Planning Sub Committee - 6 December 2021

ADDENDUM REPORT FOR ITEMS

UPDATE FOR CONSIDERATION AT PLANNING SUB-COMMITTEE Item No. 9

Reference No: HGY/2020/3186	Ward: Northumberland Park
Address: Unit 7 Unicorn Works 21-25 Garman Road N17 0UN Proposal: Erection of two-storey replacement light industrial unit Applicant: Mr Upadhyay Ownership: Private

Light Van
Swept Path Analysis
Delivery Vehicles

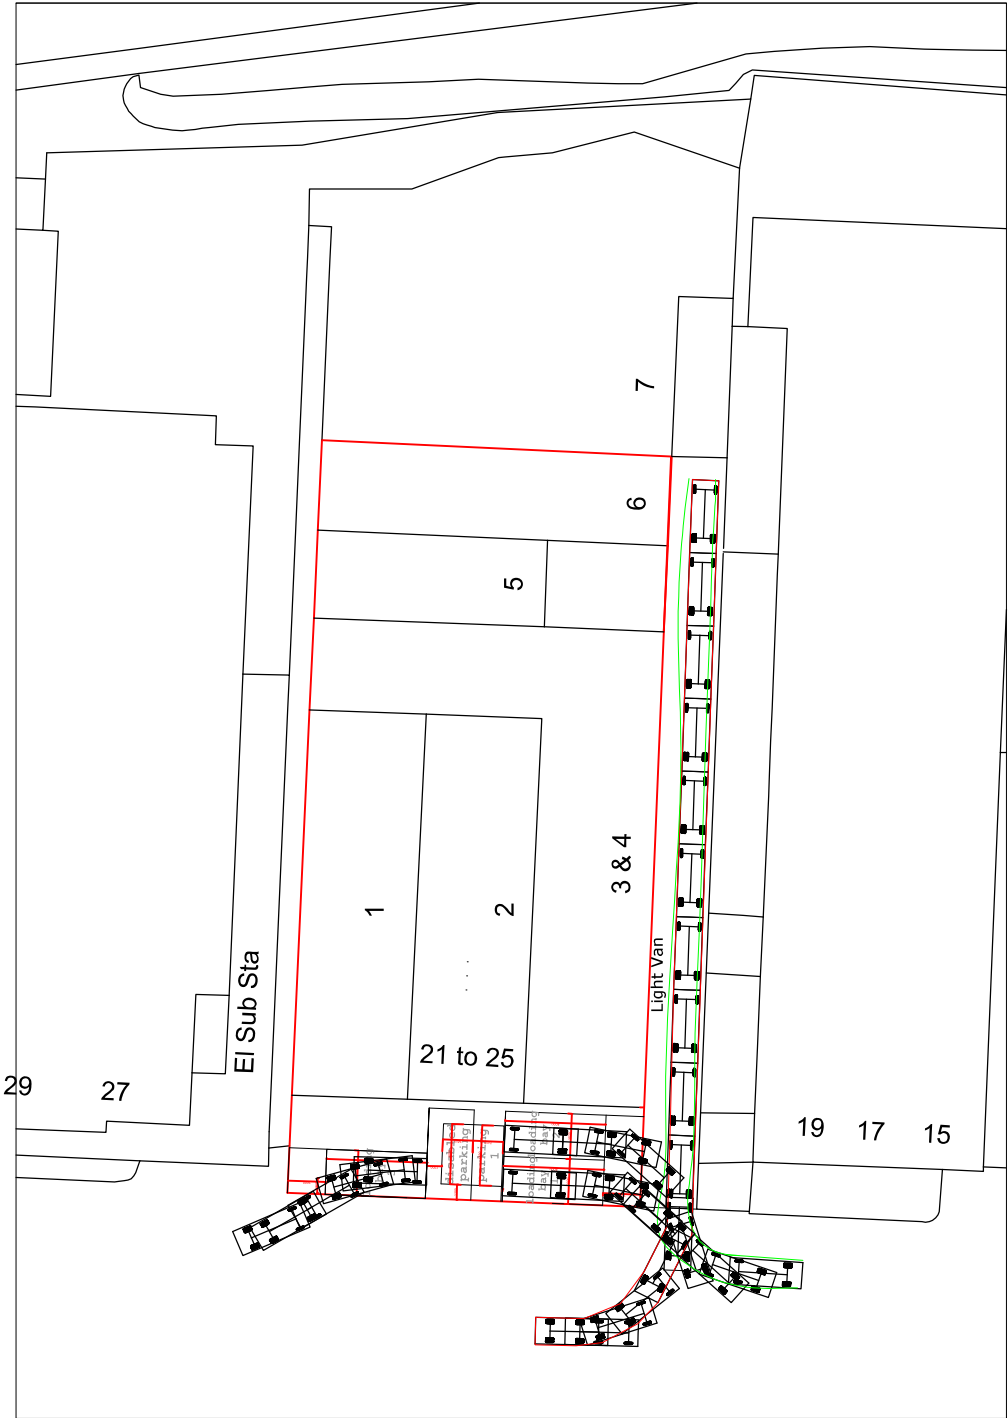
The applicant has indicated in the Transport Statement and on the plans that the units are proposed to be accessible to vans that would enter them.

Swept paths of such vehicles entering and exiting each unit, as well as the manoeuvres needed to be performed from and to the highway, were requested. In addition, it was requested that the proposed car parking spaces outside Units 1, 2 and 3A be relocated as they would block vehicle access to these units.

Considering the swept paths provided, a number of amendments to the proposed parking and loading layouts were then requested (a list of which is available in a more detailed email) to make the parking and loading layouts acceptable. The location of the existing crossovers and the structural damage to the footway along the site as a result of the fire were a starting point for and informed the re-provision of the public highway on a like-for-like basis and to high-quality standards.
